Submission of Further Information (FI)

Temporary Animal Boarding Establishment with Ancillary Facilities for a Period of 5 Years and Associated Filling of Land in "Agriculture" Zone, Lot Nos. 1486 (Part), 1489 (Part), 1493 (Part) and House Lot Block (Part) in D. D. 107 and Adjoining Government Land, Kam Tin, Yuen Long, New Territories (S.16 Planning Application No. A/YL-KTN/990)

Further Information for Planning Application No. A/YL-KTN/990 Response-to-Comment

Comments from the Fire Services Department

Photo of the existing fire hose reel pumps within a metal structure

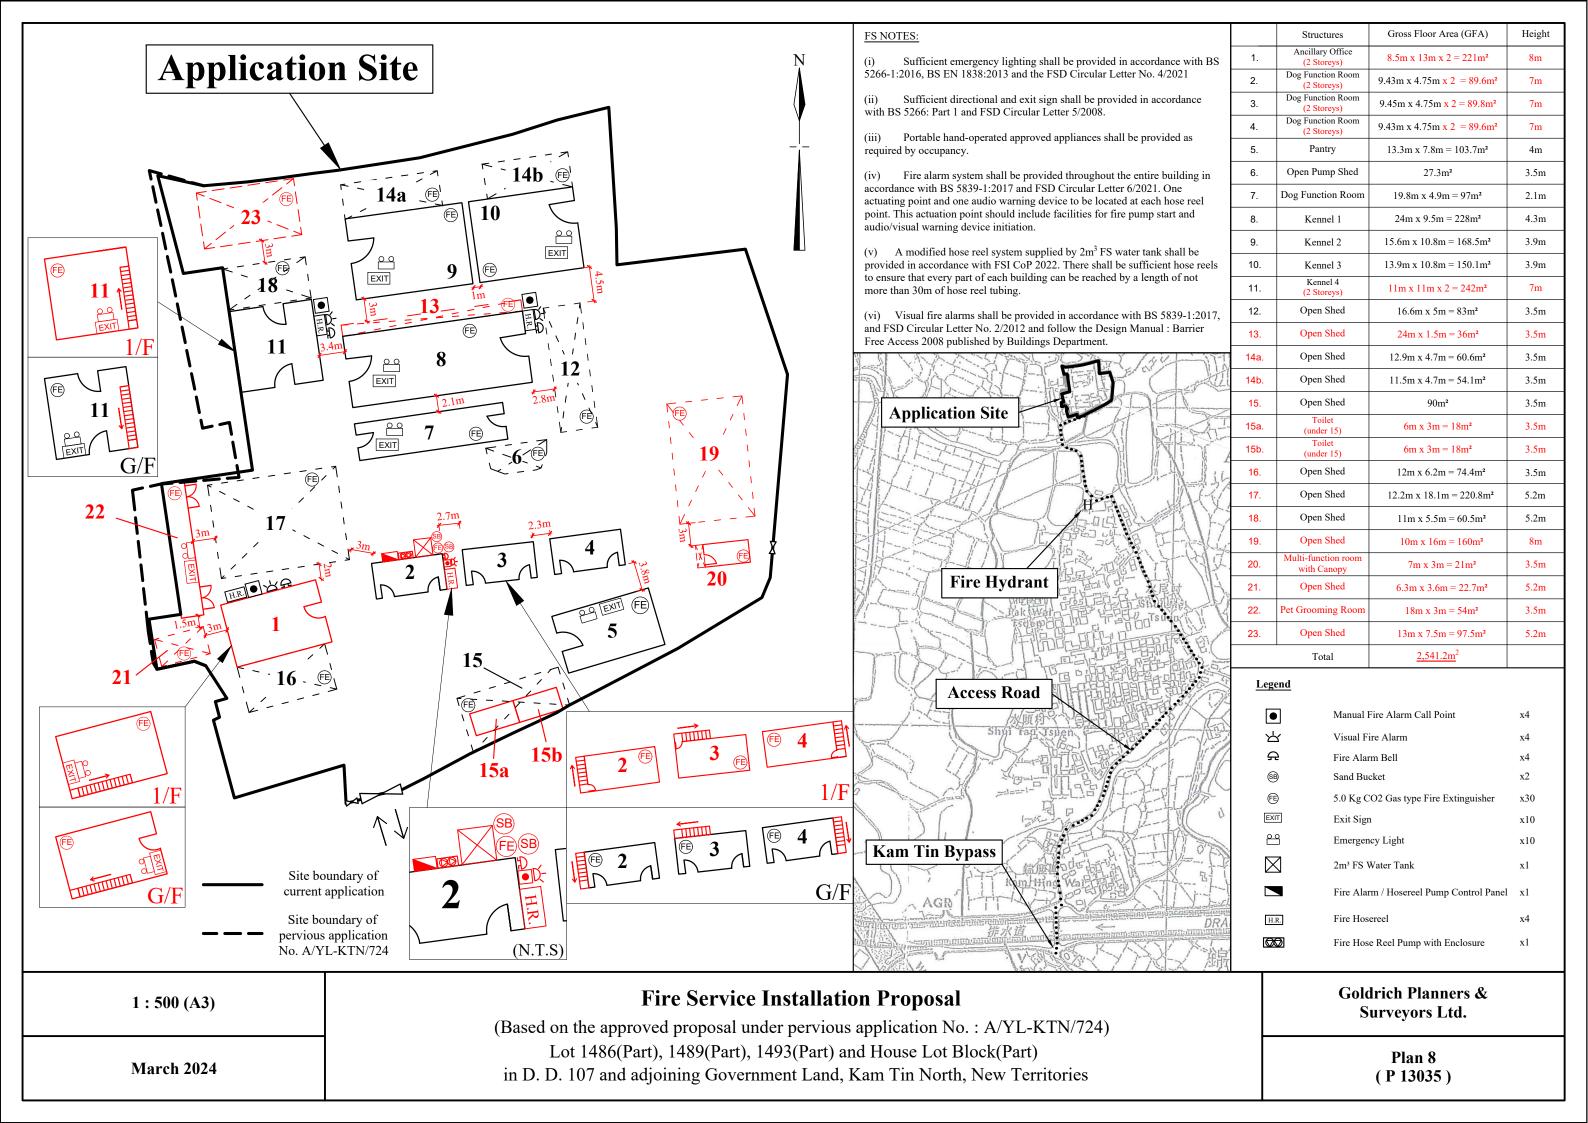
2.	Modified hose reel system shall be provided in accordance with the FSI CoP 2022.]	Noted.
3.	The FS pump room shall be provided instead of Fire Hose Reel Pump with Enclosure.	á	A photo of the existing fire hose reel pumps within a metal structure is provided. The same has been approved in the previous Fire Services Installation inspections.
